BRITISH GLIDING ASSOCIATION

TECHNICAL NEWS-SHEET 2/3/4/76

1. AIRWORTHINESS 'AGGRO'. Please add to 1976 Compendium.

76-8 Schempp Hirth

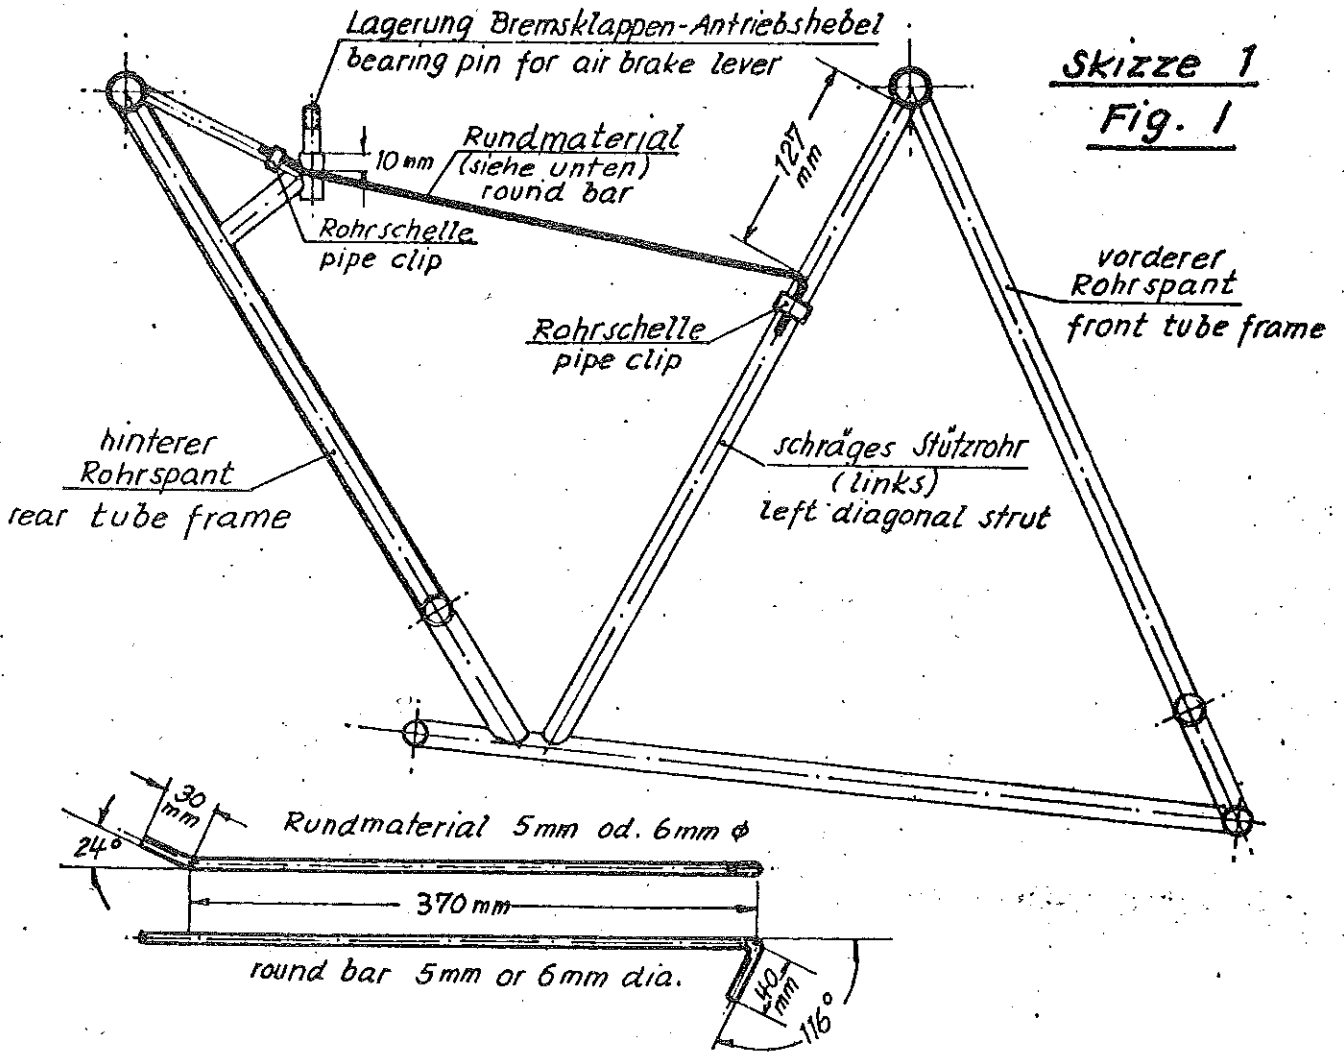
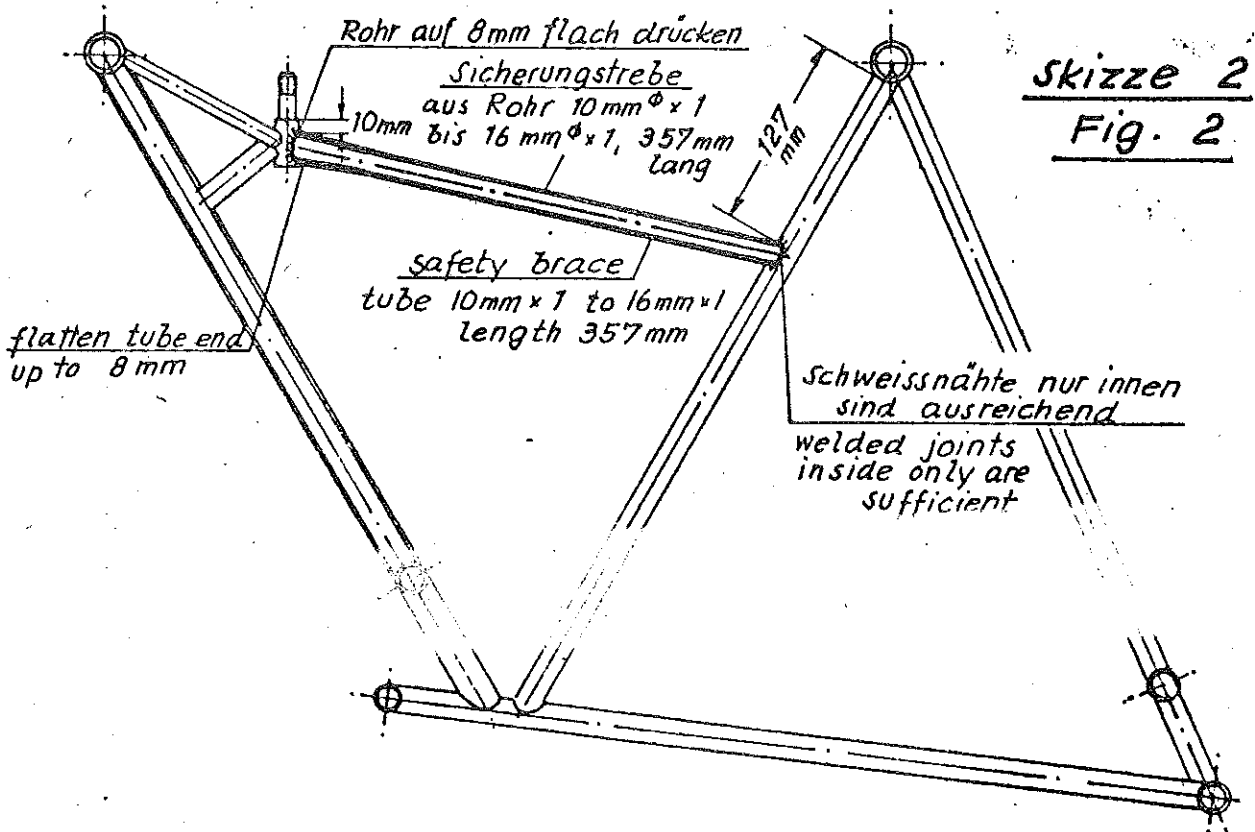
The intermediate rod may cause jamming of the aileron control, if the left aileron push rod is not connected.

Install in accordance with Technical Note a safety brace in the fuselage frame between the airbrake lever bearing and the left diagonal strut.

Versteifung der Sitzwanne  
Reinforcement of the seat

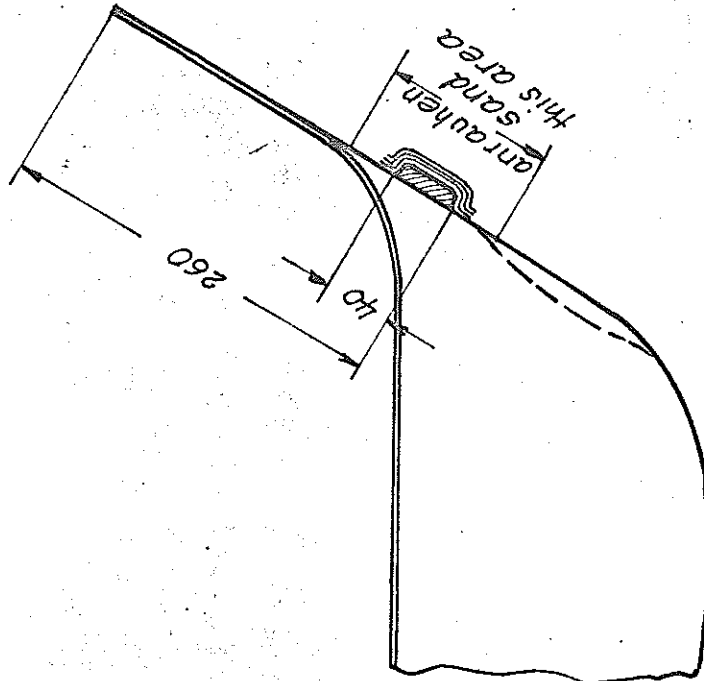
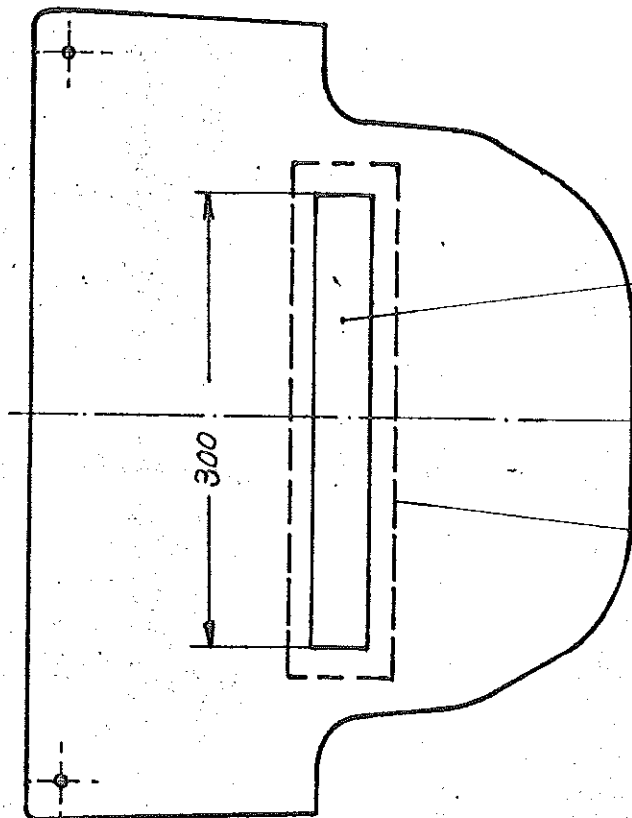
Possible jamming of the tow release lever due to warping of the seat.

1. Unless already accomplished, reinforce the seat in accordance with the instructions of the manufacturer.
2. Perform a functional test.

Abb 3

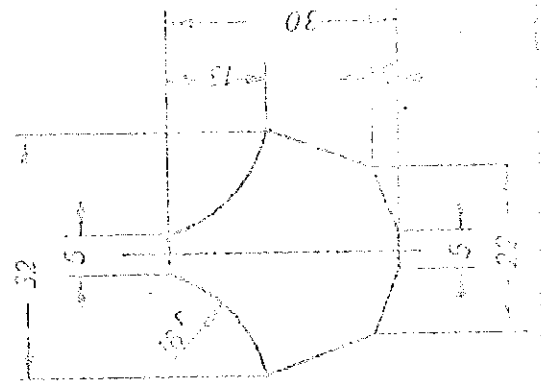
4. If cracks are observed or if the cover plate does not completely surround the the spar tube, then the reinforcement illustrated in Fig: 3 is to be fitted. (Material: Sheet metal 1 mm 1.7214.4).

Before fitting the reinforcement, the frise edge bar in the neighbourhood of the operating lever is to be removed (see Fig: 4). The paint beside the welded seams is to be removed and the surface cleaned. Cracks are to be welded. The reinforcement must be clean when fitted. It must only be autogen welded with welding wire G 1 DIN 8554.

Abb 1

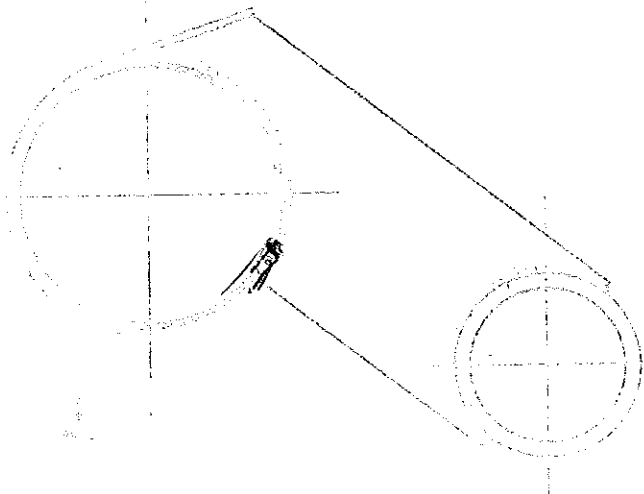
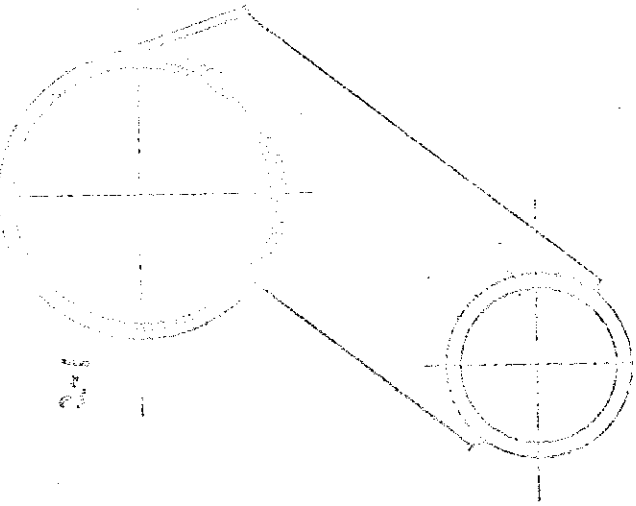
3. A check must be made to see whether the metal cover plate (1mm metal) is laid round the entire spar tube (see Sheet 3 Figs: 1 and 2).
